UTAH DEPARTMENT OF TRANSPORTATION

SUBJECT: Standards Committee Meeting Minutes and Next Meeting

| Item | Remarks | Sponsor |
|--|-----------------------------------|---|
| 5. Barrier Offset Related Standard Drawings (See listing) | For approval (doc page 80) | Robert Miles |
| 6. Supplemental Drawing BA 3C1 and BA 3C2, Precast Constant Slope Barrier | For approval (doc page 122) | Glenn Schulte |

PRECAST CONCRETE
FULL SECTION
SHOULDER
APPLICATIONS
(NEW JERSEY SHAPE)

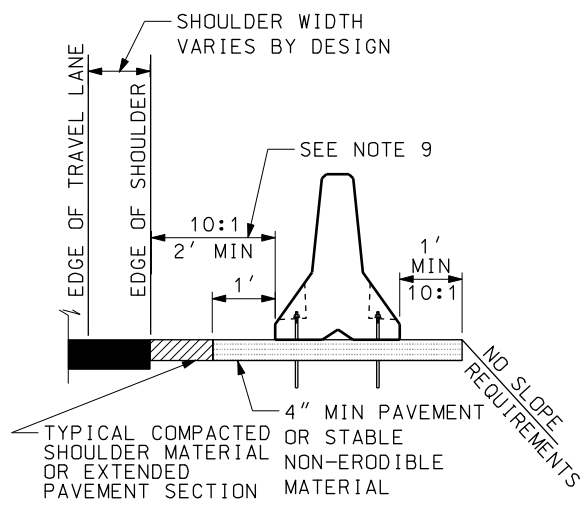
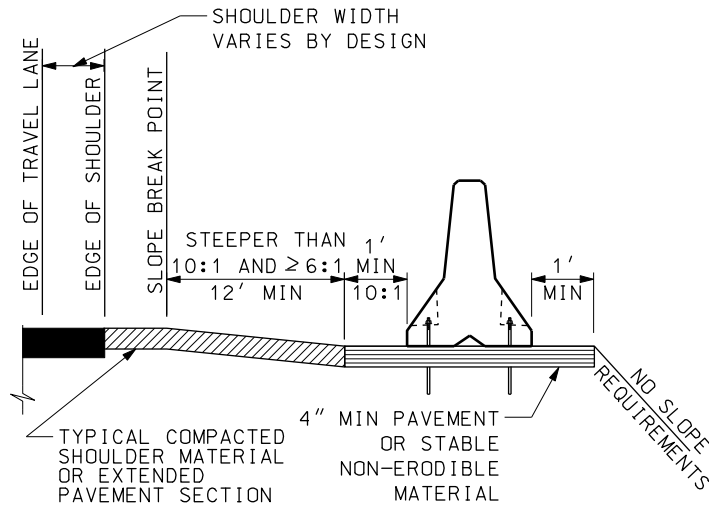
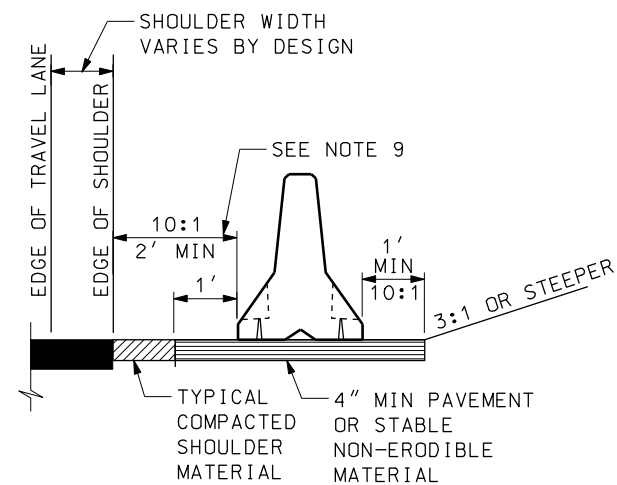
| 32b | Tyler Yorgason (email) | BA 4E2 | Also on sheet BA 4E2 they did not add the 2' offset note to the detail regarding "Barrier Installation on 6:1 Slope". Maybe that was intentional but I don't see why we would need the 2' offset adjacent to wide shoulders in that application. | Barry, Mark, Robert Miles & Glenn Schulte reviewed comments. Glenn responded to each comment | |

| REVISIONS | | NO. | DATE | APPROVAL | REMARKS |
|---|----------|-----|---|----------|---------|
| STD DWG BA 4E1 | | | | | |

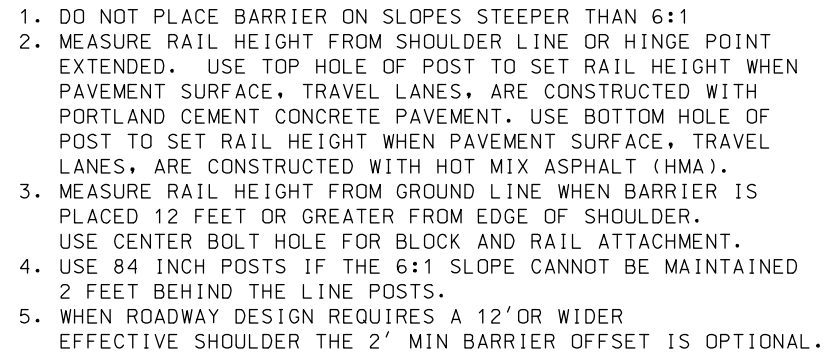
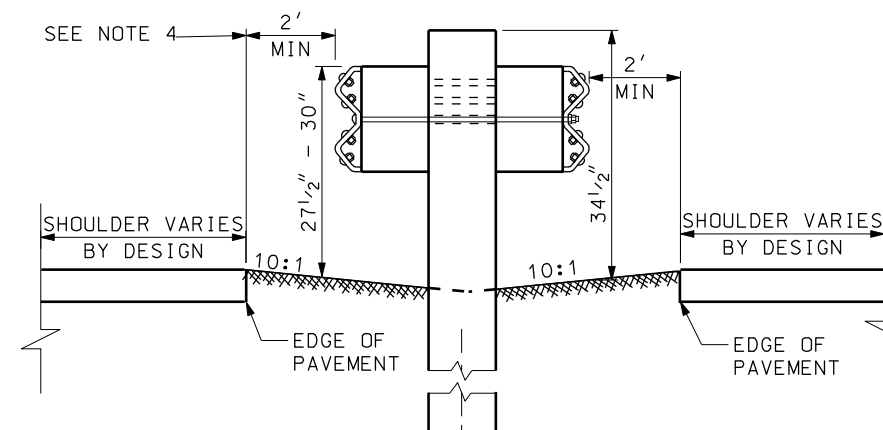
| 32d | Tyler Yorgason (email) | BA 4E1 | On Sheet BA 4E1, why not use the same note for both the standard post and the long post installation details (I like note 1 on the standard post detail). Should the note be the same across all the drawings? | Barry, Mark, Robert Miles & Glenn Schulte reviewed comments. Glenn responded to each comment | |
